Product Change Notification

PCN#: 311

Change Title: Product Recommended Solder Pad Layout Change

Products Affected: F310, F330, F340 Series: 3.2x2.5mm SMD HCMOS Oscillators.
See table on next page for as list of all affected model and part numbers.

F310, F330, F340 Series Recommended Solder Pad Change

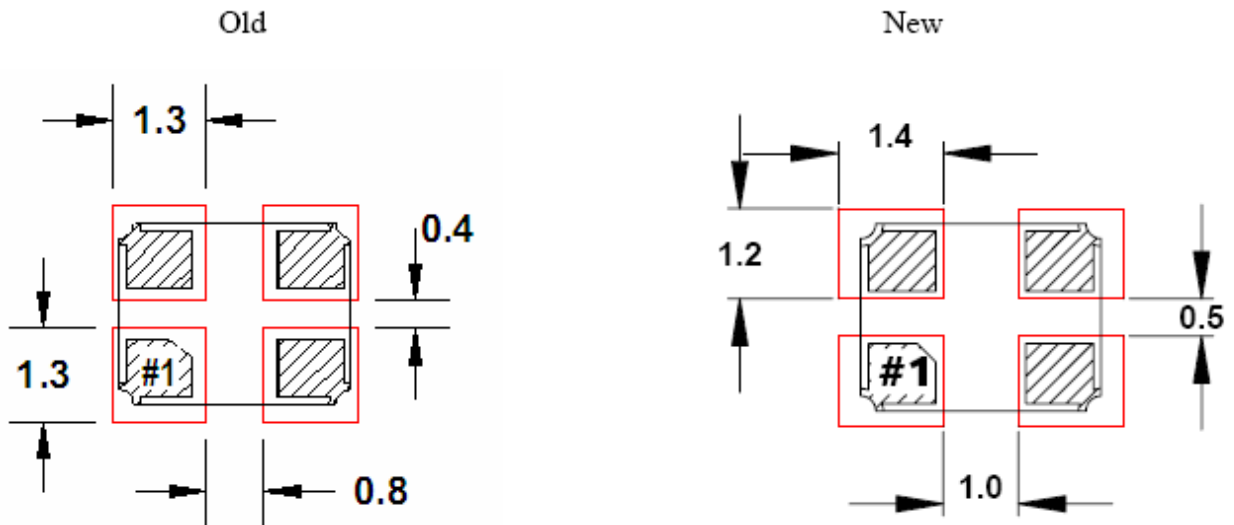
Description of Change to the Customer: To ensure PCB layout compatibility for second sourcing with our XpressO oscillators, we are modifying the recommended solder pad layout of the above products. A drawing showing the old and new recommended solder pad layout with the F310/330/340 series package superimposed is on the next page.
